**MUNICIPAL CORPORATION
KARACHI.**

Reference No. B. S. P. 168/38

With reference to your application dated 15-8-38
with a plan for the proposed buildings/additions and alterations on plot
No. 102 Survey Sheet No. M.M.6, Machi Miani Quarter,
I have to request you to comply with the following requirements:—

Re:- Plot No.102,M.M.6,
Machi Miani Qr.

SITE PLAN
SCALE 20 FT.=1 INCH.
AREA = 489 SQ. YDS.

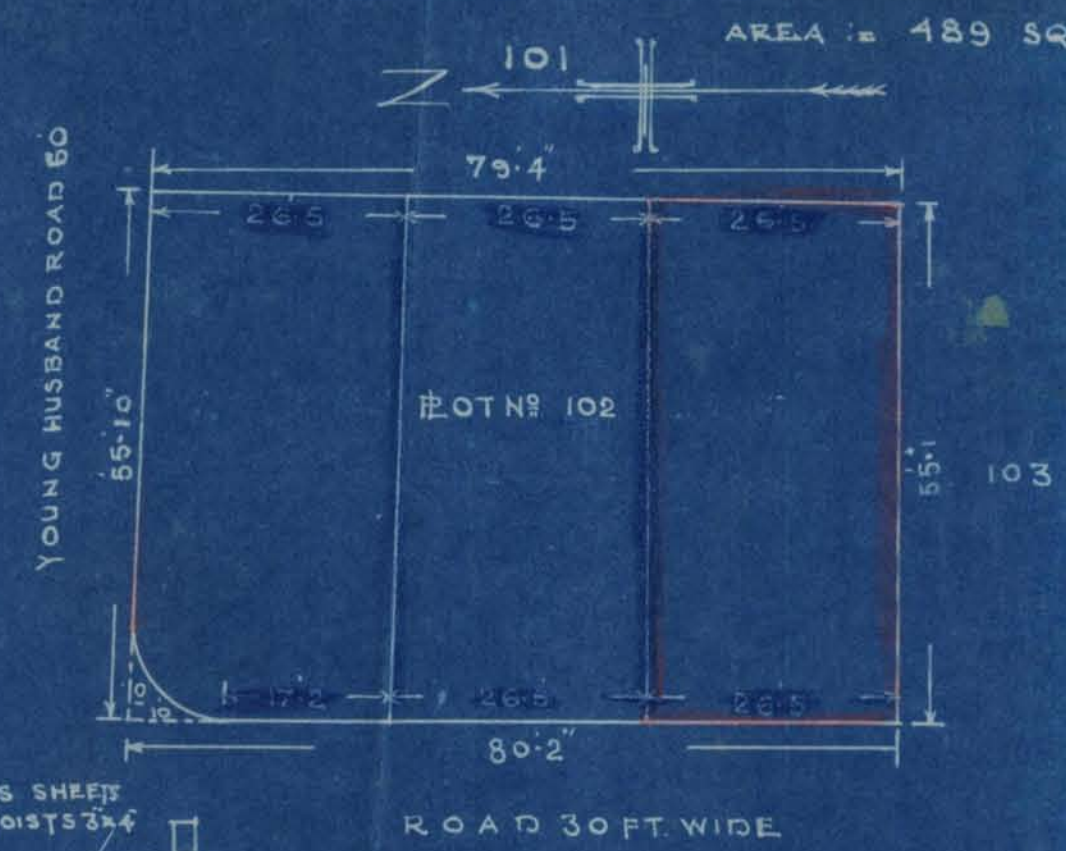
1. Site plan to be corrected by ~~the~~ deleting the middle line
& smaller dimensions.
2. Plans require to be signed by Architect.

The requirements communi-
cated have been complied with
by the Architect.

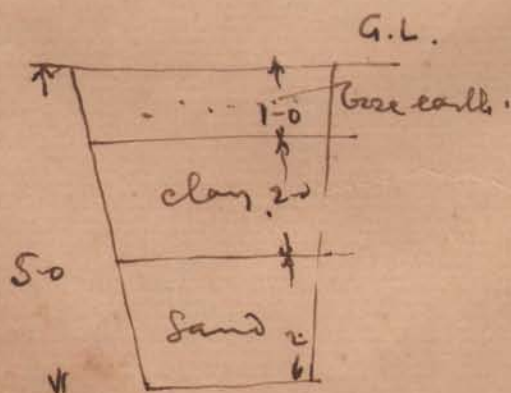
upper cabin by falling 3' from prepared
 open of 15' instead of 14' does not
 obstruct light of lower floors.

Section of foundation

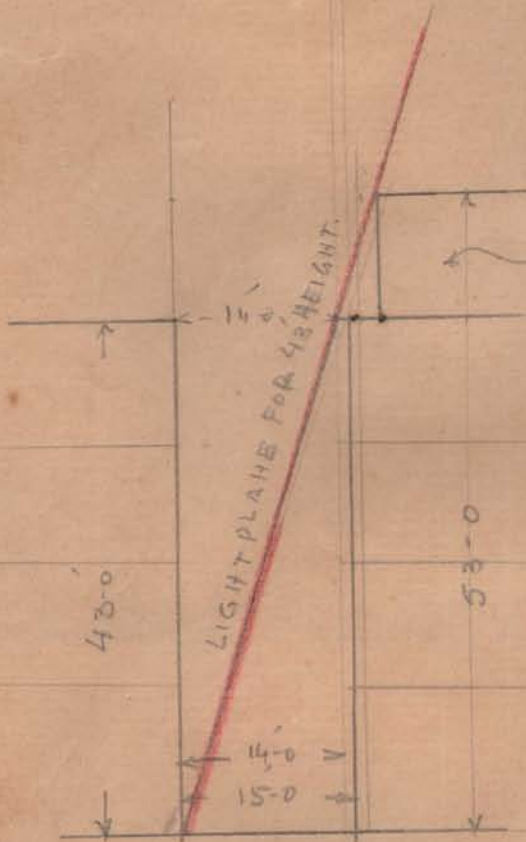
3. No projection can be permitted in the rear 3' open as that will obstruct the proper ventilation of rear rooms.
- ✓ 4. Load calculations and section of foundation trench be submitted as per recent circular.
- ✓ 5. Section is incorrect.

$$\text{Load max.} \quad 4 \times 11.25 = 45 \text{ tons}$$

$$\text{width of foundation} \quad 5 \times 5$$

$$\text{Intensity of pressure: } \frac{45}{25} = 1.8 \text{ tons/ft}^2$$

Sand can carry 3 to 4 tons safely.

— SITE PLAN —
— SCALE 20 FT = 1 INCH —

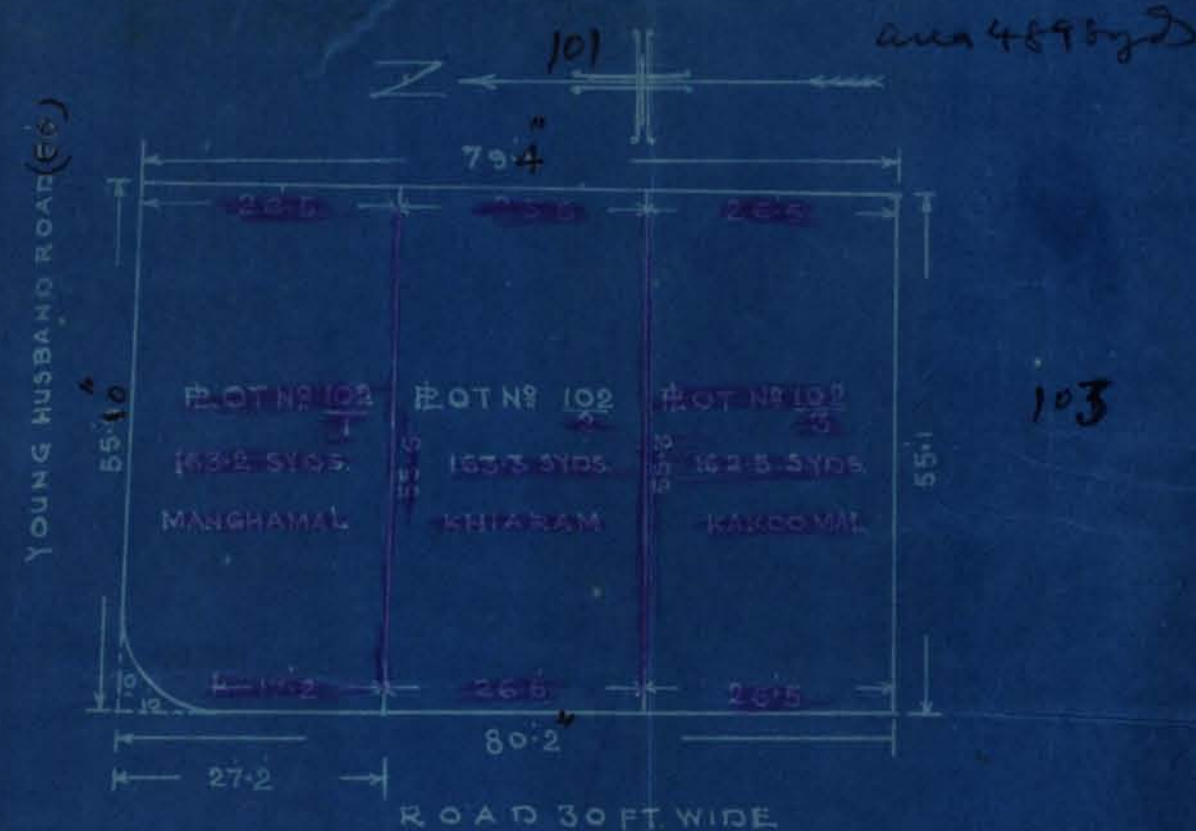
- (1) Width of Young Hussain Road to be correctly shown
(2) Adjoining plot area to be shown
(3) Side measurements to be corrected
(4) Site plan is wrong, plots are not subdivided as shown in the ~~site plan~~ it,

No objection to the site plan as corrected.
8/6
17/6/38 *6/11/6*

SECTION ON A.B.

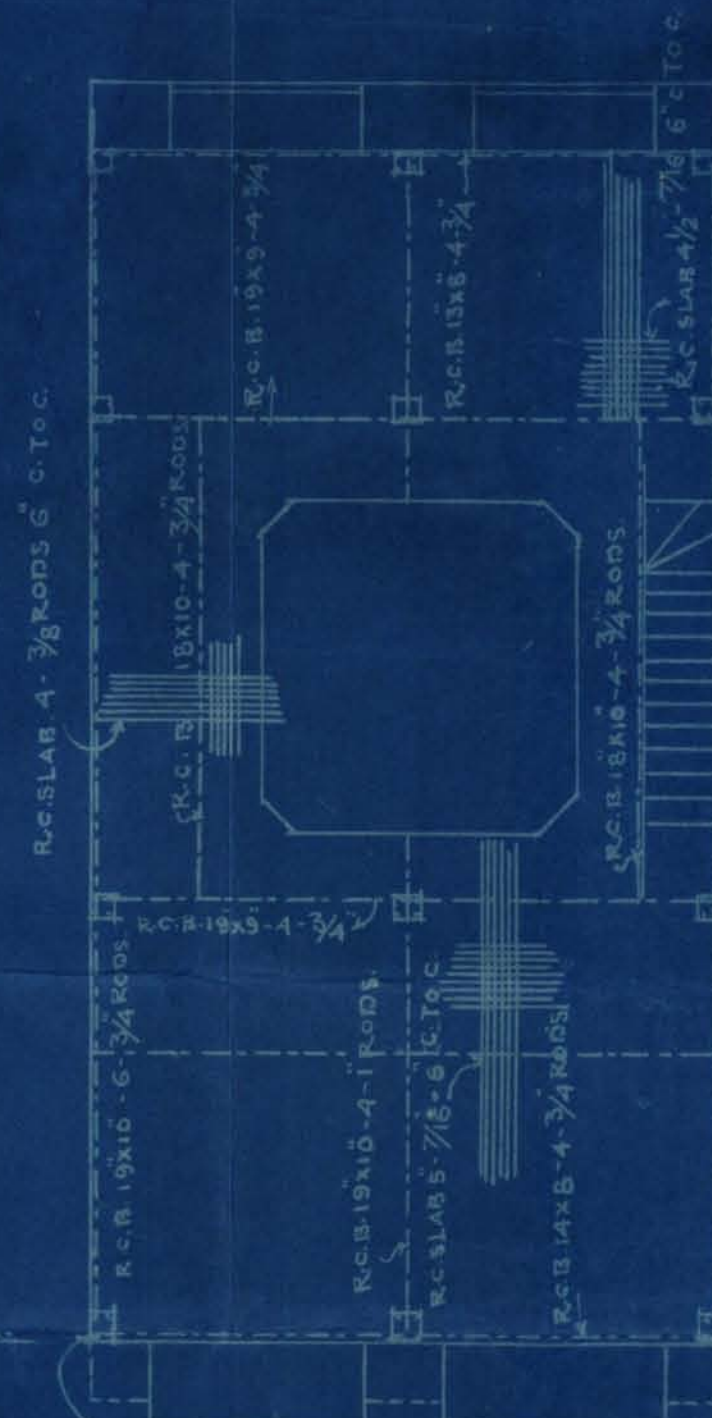
The Architect has submitted plans for building on the above plot. The total height proposed is 52'-9" above plinth level for the rear portion & 42'-9" for front portion. As the height is between 44 & 55 ft. above plinth level, an internal open of 16 ft. is necessary under the Byelaws.

But the Architect proposes an internal open of 15 ft. and then sets back on the top floor by 3 ft. at a height of 42'-9" above plinth, and requests that as the light plane is not affected (as shown in the sketch) 16 ft. internal open be not insisted upon.

I am of opinion that by setting back, the purpose of rules for 'Internal Open Spaces' will be satisfied and as such there is no objection if this is allowed.

Pl. Communicate objection viz 16ft internal open be left right from plinth level.

d.m.A. I think even up to 16ft back he decreases the plane of light and air and he should be called upon to comply with the rules
3/8/38

- (1) Gully at rear is increased from 3' to 4'.
- (2) Rooms about on the internal open space of
12' x 15' which is as per rules, hence there should
not be objection to it. The rear gully is meant only
for cross ventilation. It is not a source of light.
- (3) The rear gully is increased from 3' to 4' and
the proposed balcony on the 2nd floor is
in front of room ~~which~~ ^{which} is ~~absolutely~~ ^{absolutely} clear & sides
such type balcony ~~has been~~ ^{has been} ~~permitted~~ ^{permitted}.
Hence the objection has been ~~removed~~ ^{removed}.
- (4) Load calculations ~~are~~ ^{are} ~~being~~ ^{being} ~~sent~~ ^{sent} ~~to~~ ^{to} ~~you~~ ^{you}.
- (5) Section has been ~~corrected~~ ^{corrected}.

Re: Proposed cabin on the rear ~~gully~~ ^{gully} may
state, the internal open space ~~from~~ ^{from} height of 55'-
15" 16". The proposed space is 15' for a height of
55'-0". But the 1st floor cabin is set back three feet
which will not obstruct the light plane for lower
floors which require only 14' wide space while
15' is actually being provided. Under the circumstances
the cabin should not be objected to. A diagram
of light plane is attached herewith ^{which} ~~be~~ ^{be} ~~approved~~ ^{approved}.
Yours faithfully,
R. G. Chawla

SITE PLAN

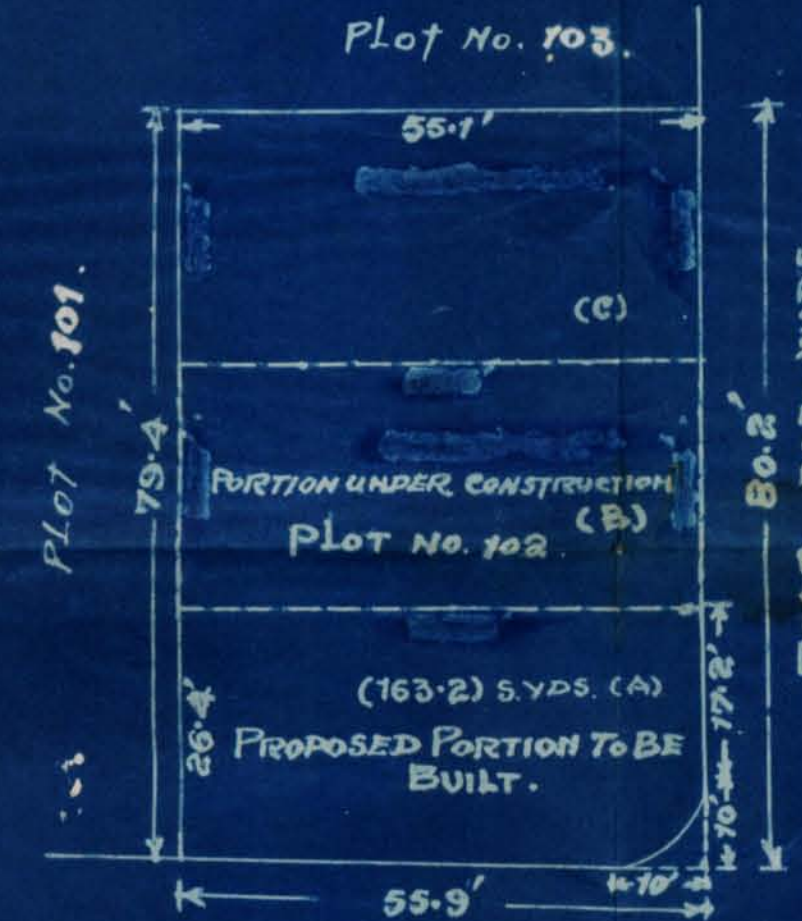
- (1) Side measurements to be correctly shown
- (2) Width of Young Husband Band to be shown
- (3) Cardinal direction to be correctly shown

L.S.
objection compliant
by the Architect
No objection
To _____ L
26/5
